DEVELOPMENT ASSESSMENT REPORT

Application No.	10.2018.139
Address	38 Dalhousie Street, Haberfield
Proposal	Alterations and additions to an existing dwelling, including the construction of a new garage and swimming pool.
Date of Lodgement	31 July 2018
Applicant	Amy & John Raneri c/o Sago Design
Owner	John Raneri
Number of Submissions	Nil.
Value of works	\$1,524,188.38
Reason for determination at Planning Panel	Proposal seeks consent for the partial demolition of a local heritage item
Main Issues	Impact upon the heritage item, impact upon existing on-site trees
Recommendation	Conditional Approval
Attachment A	Recommended conditions of consent
Attachment B	Plans of proposed development

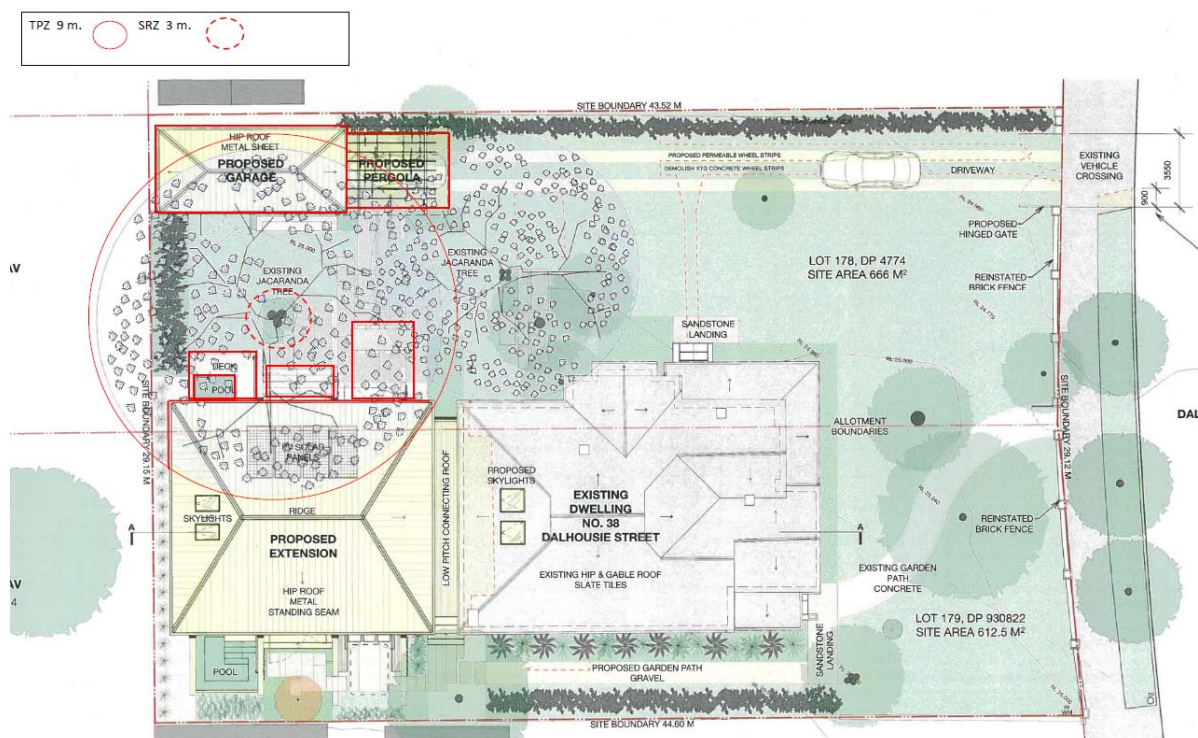
The development seeks consent for new works to take place within a close proximity to tree 15 a significant and healthy Jacaranda tree (as identified by the Arboricultural Impact Assessment (AIA) prepared by Australis Tree Management dated 31/05/2018). Council's Tree Management Officer has reviewed these proposed works and notes that the arboricultural report has miss-calculated the extent of the proposed encroachment.

In this instance the extent of the proposed encroachment into the Tree Protection Zone (TPZ) for tree 15 has been calculated at 35 - 40% encroachment into two sides. This is expected adversely impact upon the health and stability of the tree.

At this time the applicant has not provided sufficient information to determine if the proposed works will destabilise or kill tree 15. Council has previously asked for the preparation and submission of a root map investigation report for this tree, to determine the exact location of its roots. However as outlined above the applicant has expressed strong objections to the

The Root Mapping Reports once completed must be submitted to Council, along with information regarding construction techniques to be utilised to ensure minimal impact to the tree. This information is then to be assessed by Council's Tree Management Officer, who will provide approval for the proposed construction methods within the Tree Protection Zone of 9 metres.
